Hillmont

Applicant drawings dated 09-05-23

Design Comments

Prepared by: Brian Peterson, AIA, Urban Designer, T.O.C.H.
09-21-23

Diagram 1

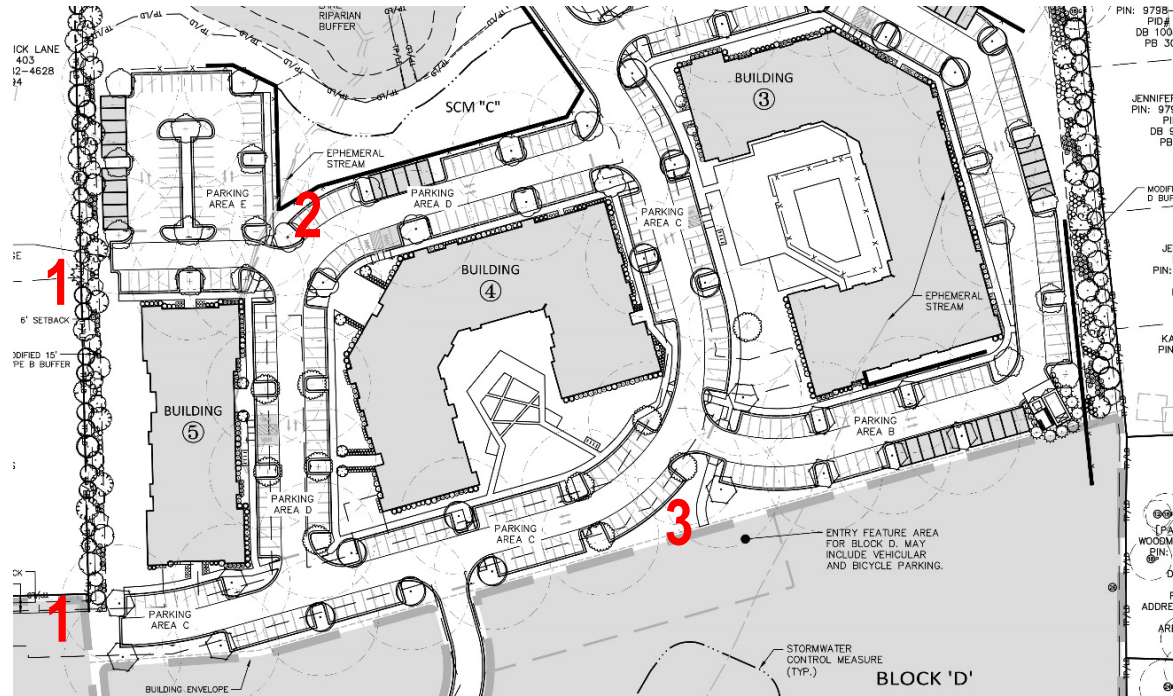
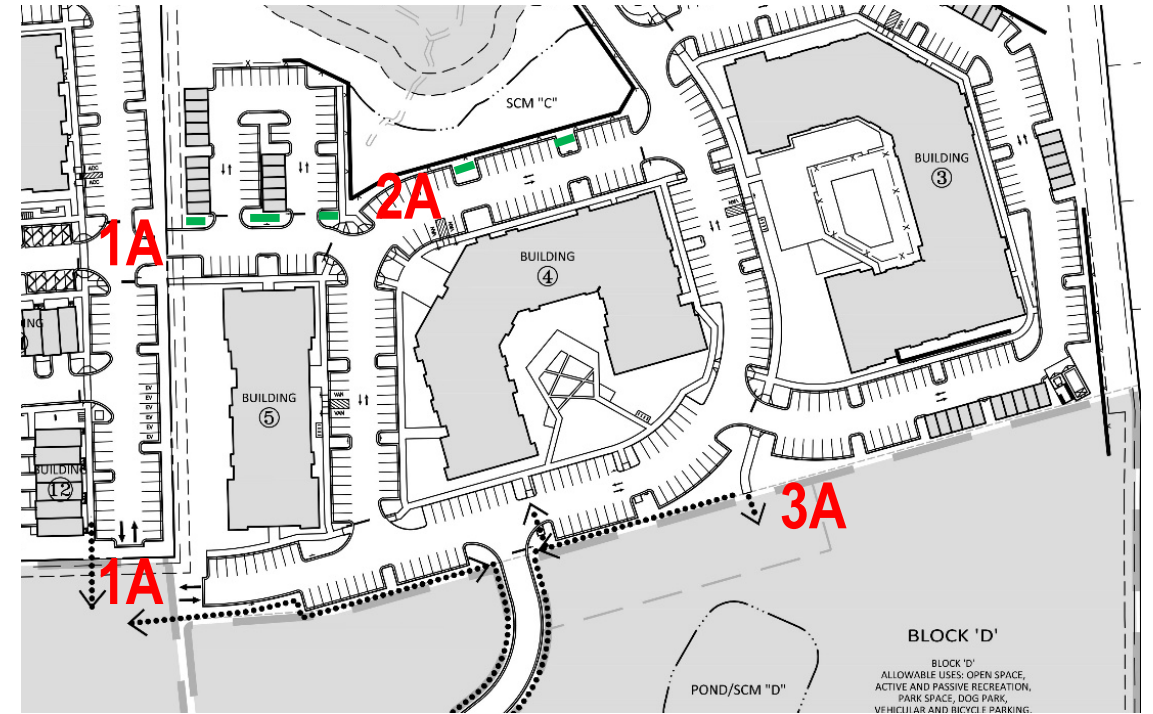
1. Two important locations for street and sidewalk connections into the Barbee Chapel Road (BCR) multi-family project are not indicated. Street connection is vital to the integration of the two projects.

3. Consider ways in which to make the main pedestrian entrance to the proposed central park into a more visible and welcoming place.
 - 3A. Per suggestion, the bump outs where the multi-use pathway crosses into the park have been widened on both sides of the street, providing more area for plants and other landscape features which could help create a sense of entrance.

- 1A. The intention to connect the streets and sidewalks has been verified, at both locations. Both property owners have worked to coordinate this.
2. The street/parking frontages along this segment need improvements to enhance the landscape and streetscape character as well as to provide some continuity with BCR.

- 2A. The garages which had previously been located along the northern edge of the parking have been relocated to an off-street location in the parking lot near the RCD/stormwater area. Five trellis/pergola features (green lines on Image 2) have been added, per suggestion, to provide vertical and space defining elements along the northern edge of the frontage, and to add some scale to the parking area. Landscape bump outs in the parking areas have, in some cases, been realigned, to match locations across the street to give better rhythm to the landscape character. Bump outs at the southern end of the garages have been enlarged to provide more room for landscape between the street and the garage edges. The sidewalk location will be on the south side of the street, which is where the sidewalk connection to BCR is proposed.

Image 3: Urban Designer
Additional Comments on 09-05-23
Plan

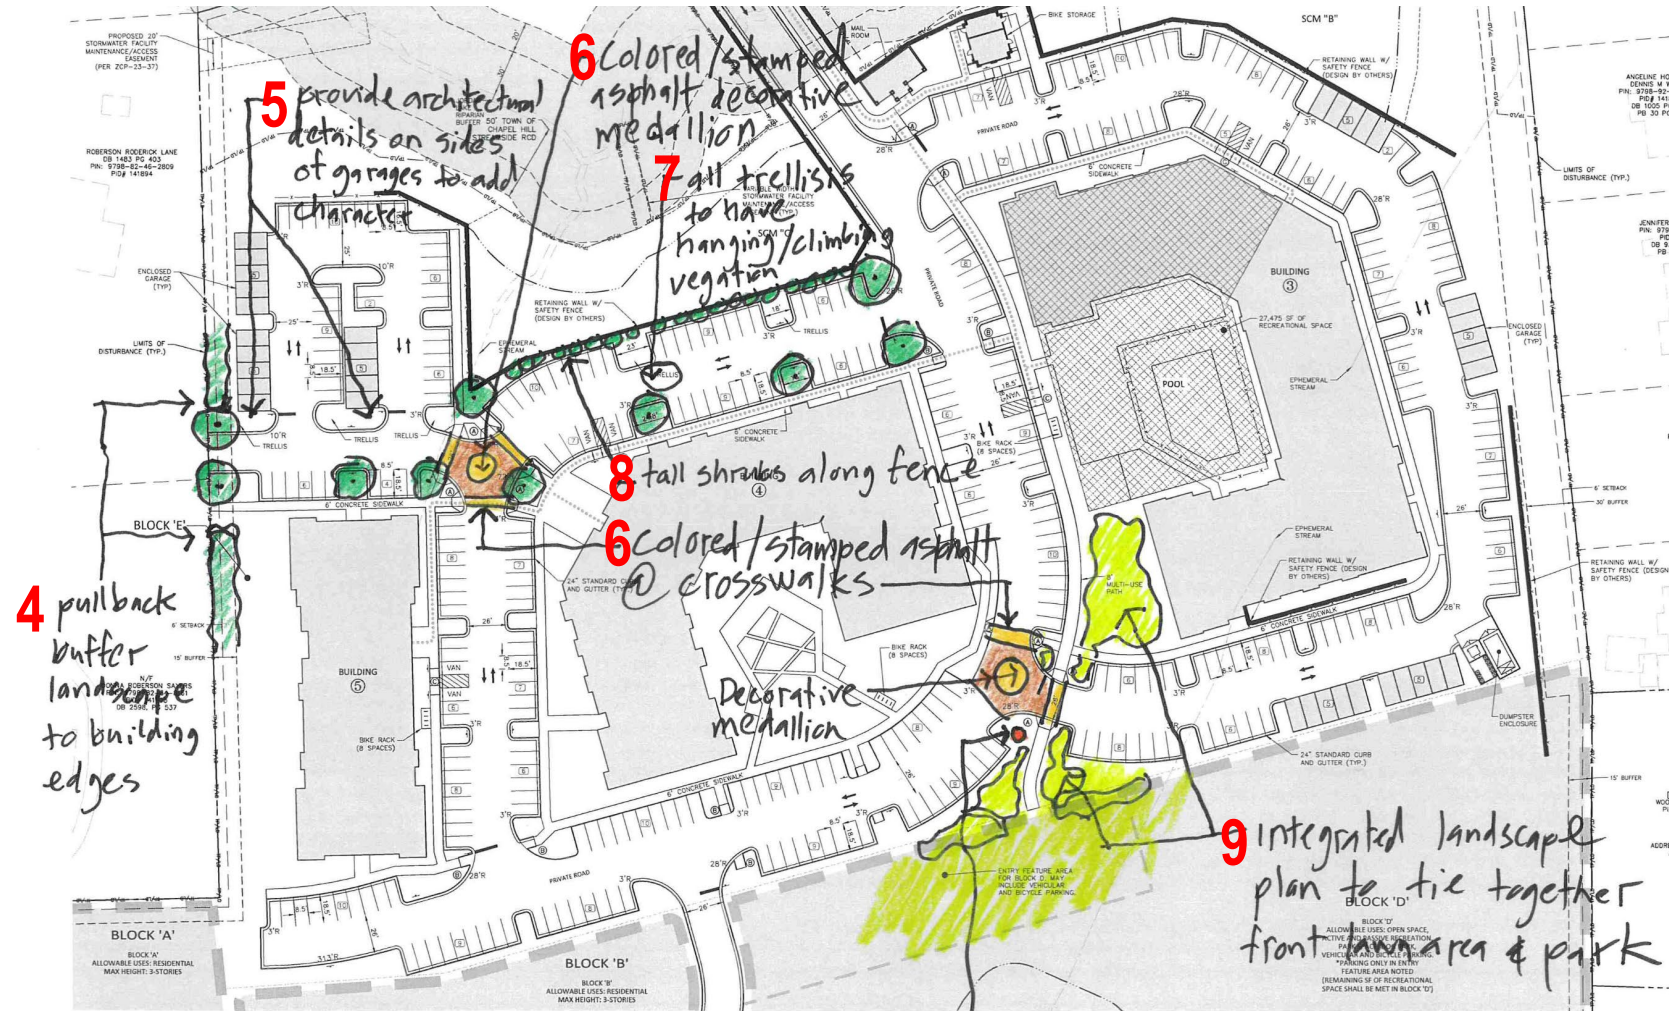
4. Pull back the buffer landscape to align with the building edges, to provide for visual connectivity along the street between the two developments.
5. Provide architectural details on the side elevations of the garages along the street to add to the streetscape character.

6. Provide colored/stamped asphalt, or other paving enhancements, at the intersection in the form of crosswalks and a decorative medallion. In addition, consider a similar treatment at the entrance area to the neighborhood park. Another location which was discussed included the main entrance point for the project, just south of Stancil Drive.

7. All trellis/pergola structures should have hanging/climbing vegetation to create a “green wall” effect.
8. Provide tall shrubs or small trees between the fence and the edge of the parking, to enhance the streetscape/landscape character.

9. Create an integrated landscape approach to tie together the front lawn area in front of Building 3 and the neighborhood park into one coherent entrance experience into the park.

10. In this portion of the park entrance, consider placing a vertical landscape element, architectural feature, or sign to act as a view terminus from the main north/south street, and to help establish a “gateway” into the park.

10 Vertical park element to create focal point at street view terminus and "gateway" into park
